## **WATERFRONT RESUBDIVISION**

APPLICATION NUMBER 24 DATE December 4, 2003

# WATERFRONT SUBDIVISION

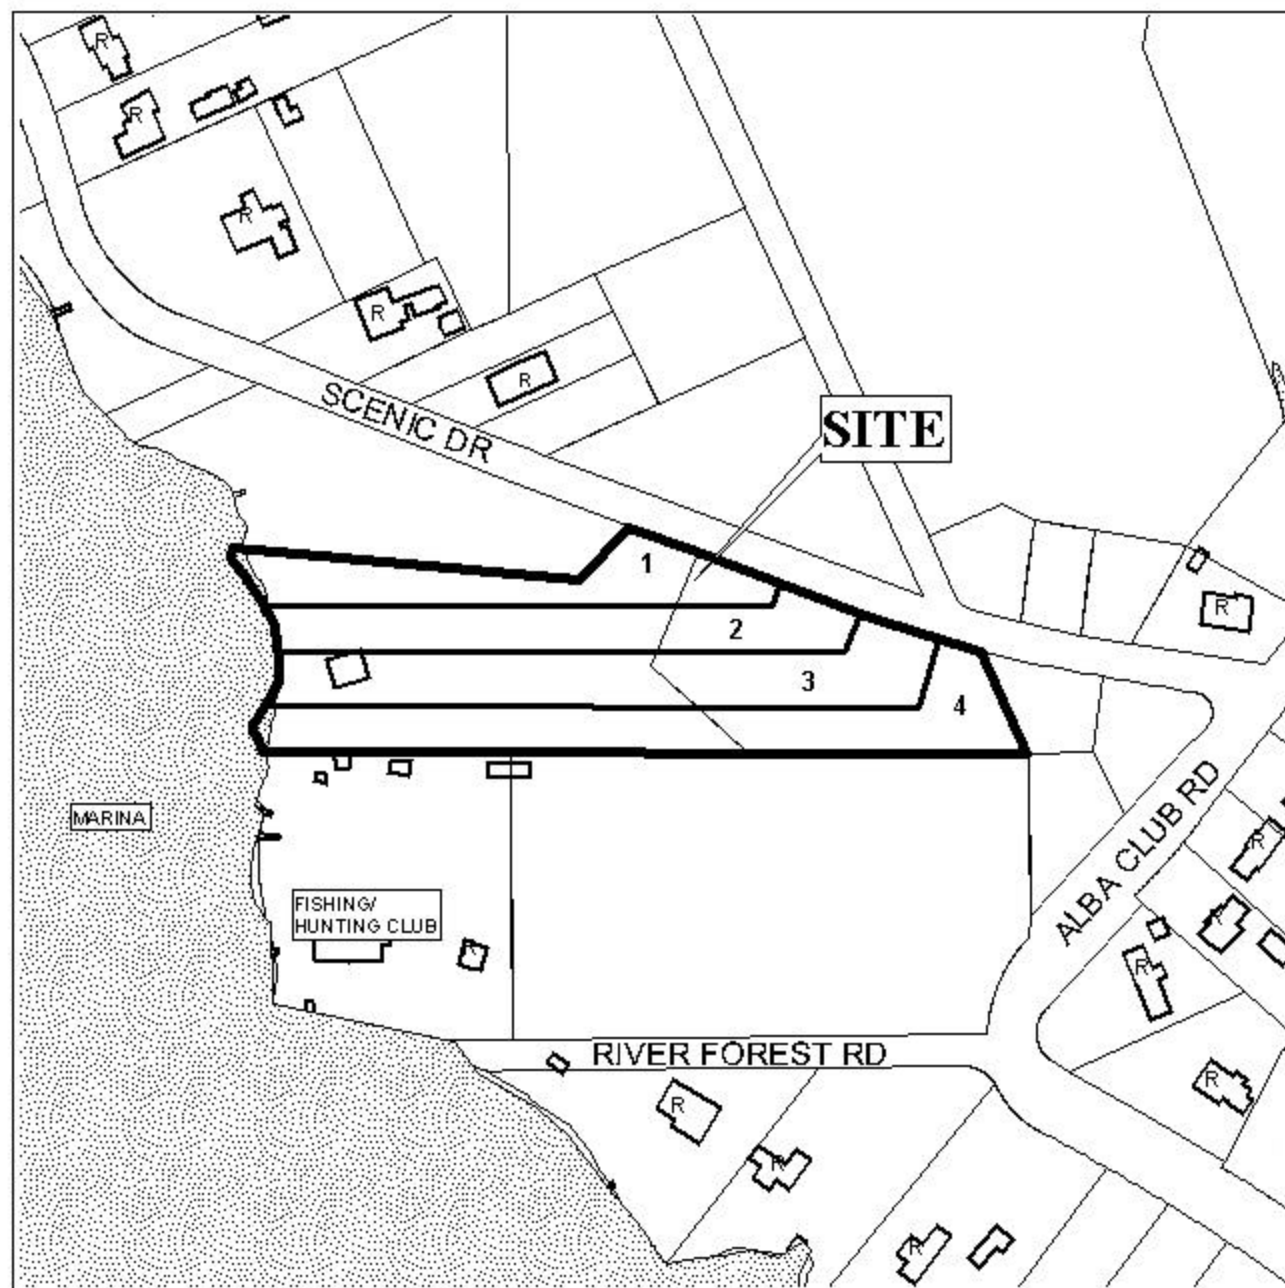
The plat illustrates the proposed 4 lot, 5.7 ± acres subdivision which is located on the West side of Scenic Drive at the Southern terminus of Inerarity Road. The subdivision is served by public water and sanitary sewer.

The purpose of this application is to subdivide two legal lots into four lots of records.

As a method of access management, the placement of a note on the final plat stating that Lots 1, 2, 3 and 4 are limited to one curb cut each to Scenic Drive, with the size, location and design to be approved by Traffic Engineering, should be required.

As indicated on the plat, the site is located on Dog River and as such the area may be considered environmentally sensitive; therefore, the approval of any necessary federal, state and local agencies would be required.

With modifications and a waiver of Section V.D.3., the plat meets the minimum requirements of the Subdivision Regulations and is recommended for Tentative Approval subject to the following condition: 1) the approval of all applicable federal, state and local agencies prior to the issuance of any permits.
